Marvel-Schebler/Tillotson

SERVICE BULLETIN

#A1-81

SUBJECT: Model HA Carburetor Float Shaft and Bracket Wear

FIGURE 1

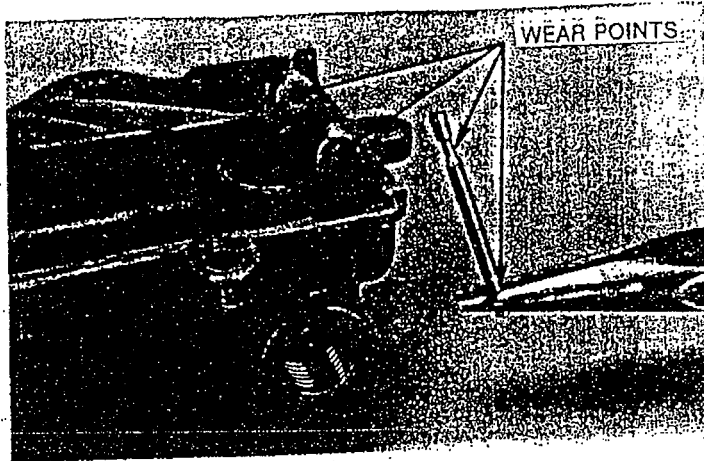
FIGURE 1 shows this wear condition which has been noted in some carburetors.

Use a #30 drill blank as a gage to check wear limits of both holes. If the #30 drill blank will enter either hole the wear limits are exceeded, a new casting is required.

If during inspection a worn casting is detected, a new cover must be used, as the worn float shaft hole will not accept the knurled float shaft press fit. A new cover can be ordered from your supplier from the following list which shows the HA Carburetor model number and the new cover assembly required.

A kit can be obtained from your supplier to make the change to the new knurled pin. This kit is part number 666-824. It consists of the new knurled pin, the bowl cover gasket and 6 cover screw tab washers for re-safetying the carburetor.
